## Town of Ridgeland

**PROJECT:** Town of Ridgeland Well Site No. 3 Improvements  
TOR-2024-03

**ADDENDUM:** Two (2)

**A-5**

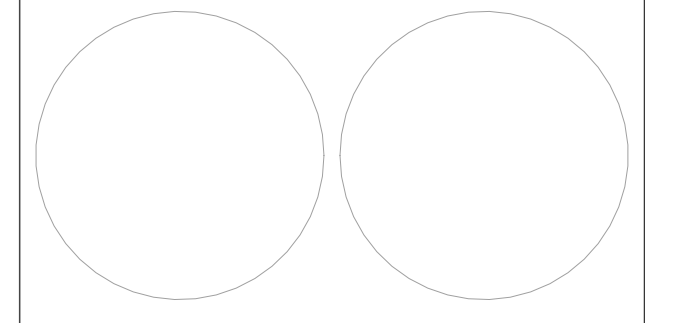
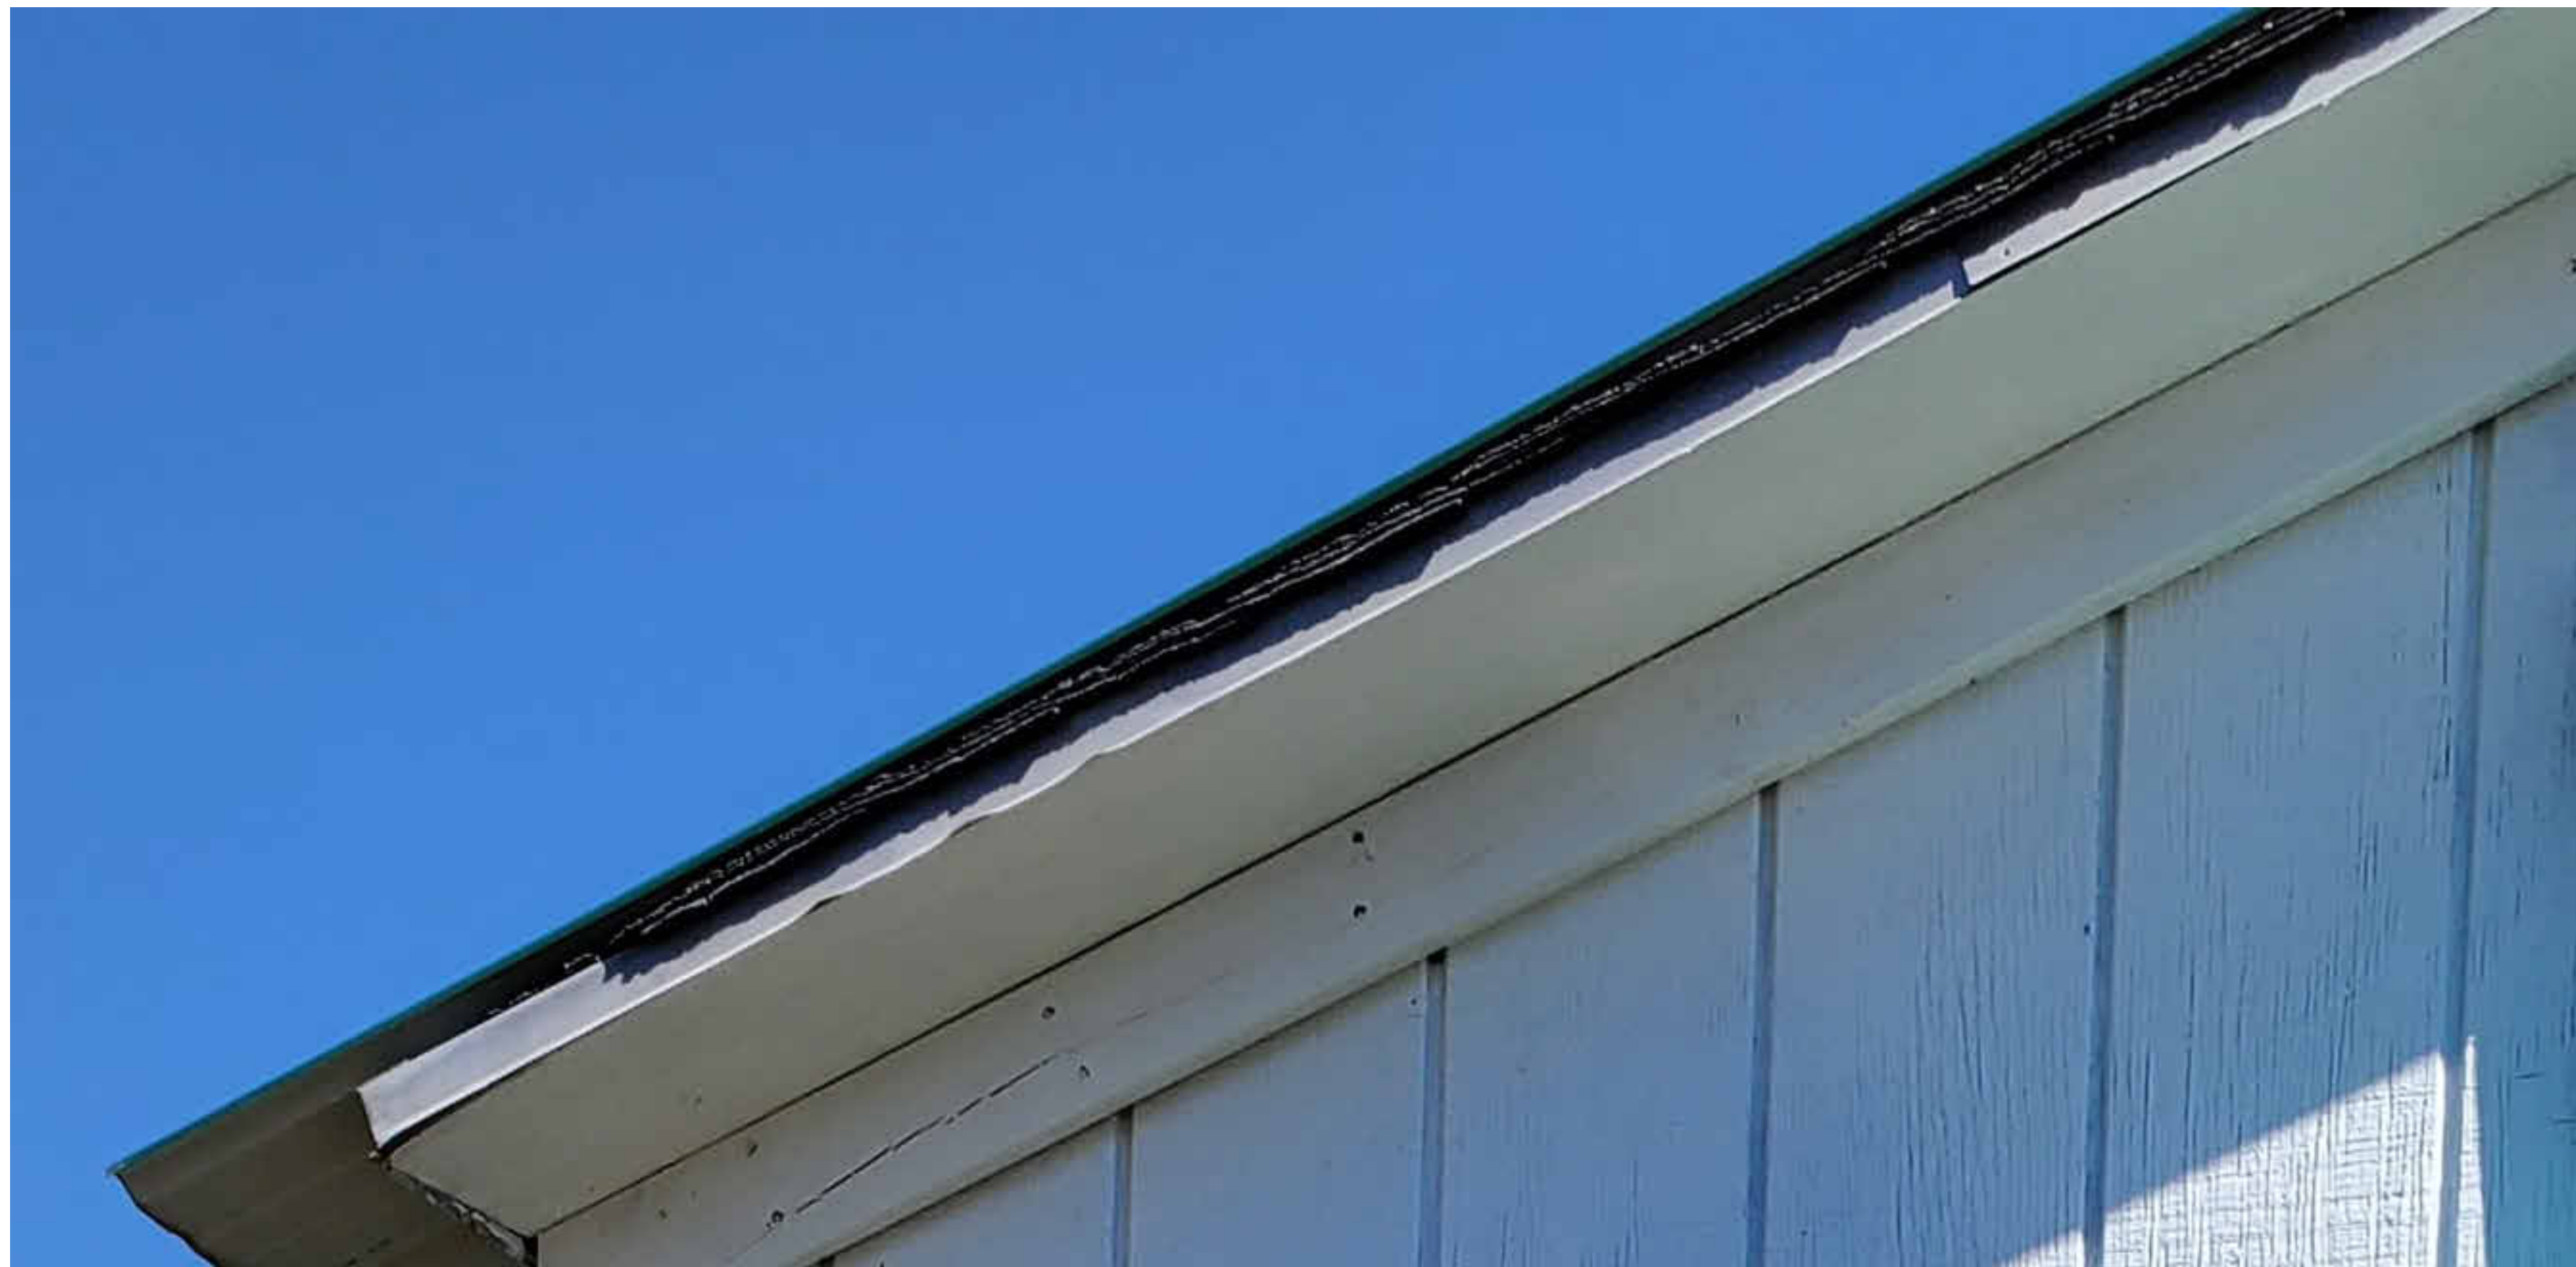
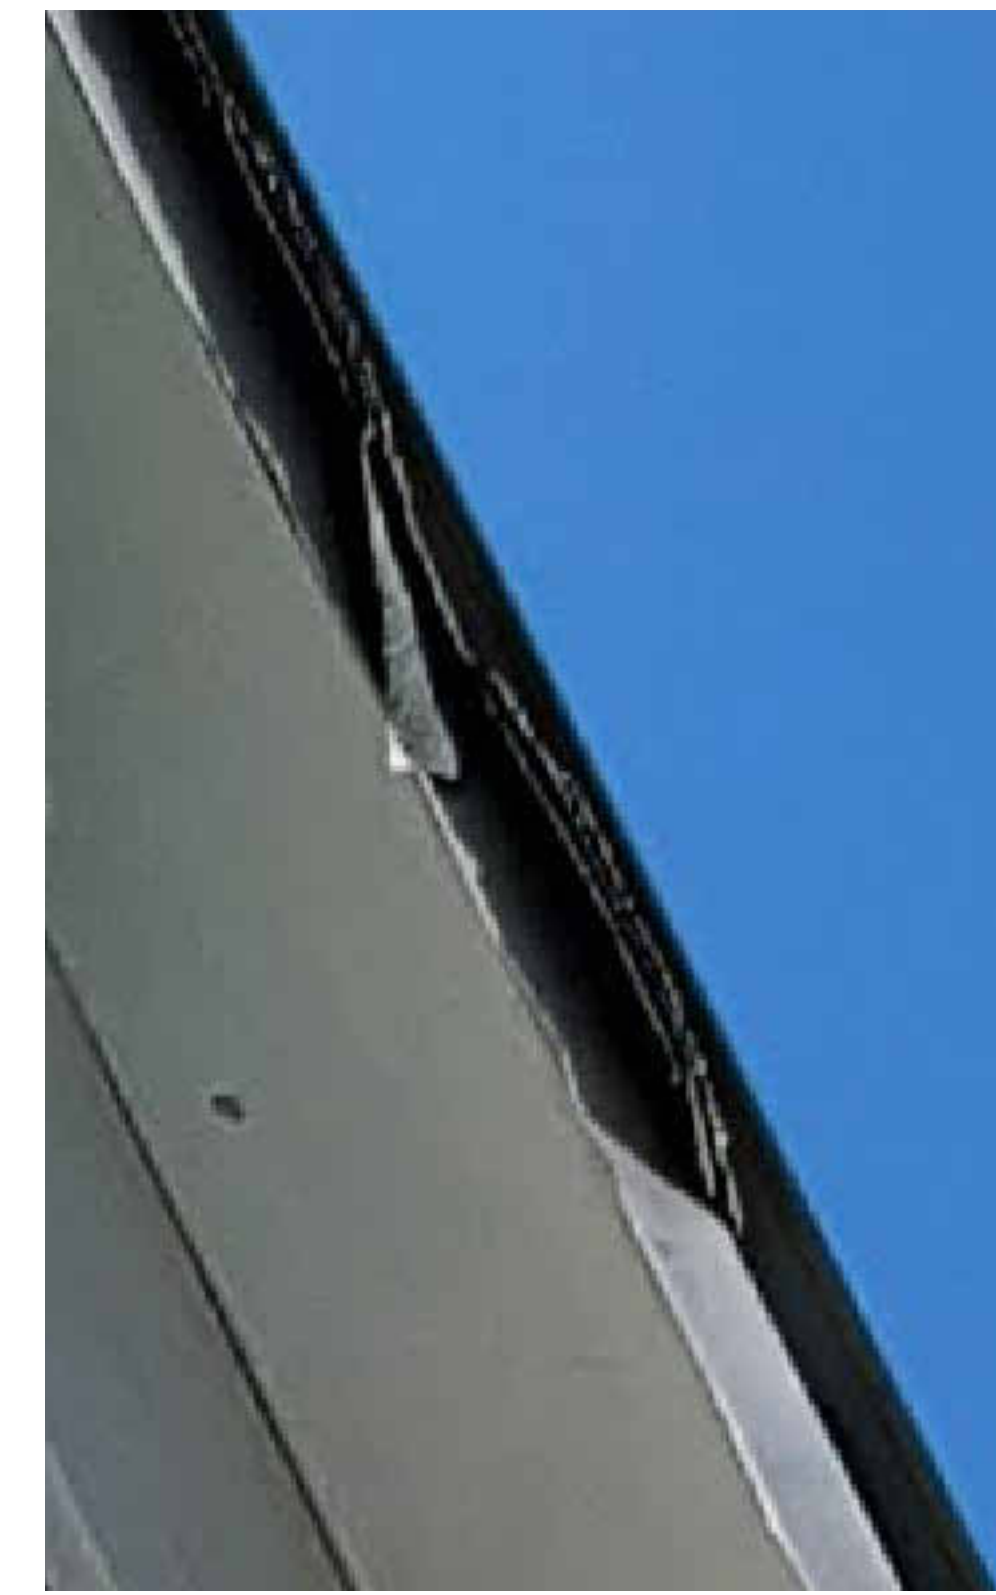
1. Plans indicate to remove existing standing seam metal roof and replace with new standing seam metal roof. The existing roof does not appear to be standing seam. Please provide metal roof spec.

Plans indicate to remove existing standing seam metal roof and replace with new standing seam metal roof. The existing roof does not appear to be standing seam.

Please provide metal roof spec.

***Response: (Reference notations on drawing A-5 at end of Addendum No. 2)  
For clarity see photos above. Existing standing seam roof to be removed along  
with what appears to be a asphalt shingle layer below.***

***Provide a new layer of ice and watershed membrane and standing seam metal  
roof similar to product provided by 4M Metals 843-208-2433 or approved equal.  
Color to be chosen by Owner.***

FOR CLARITY SEE PHOTOS ABOVE. EXISTING STANDING SEAM ROOF TO BE REMOVED ALONG WITH WHAT APPEARS TO BE A ASPHALT SHINGLE LAYER BELOW. PROVIDE A NEW LAYER OF ICE AND WATERSHIELD MEMBRANE AND STANDING SEAM METAL ROOF SIMILAR TO PRODUCT PROVIDED BY 4M METALS 843-208-2433 OR APPROVED EQUAL. COLOR TO BE CHOSEN BY OWNER
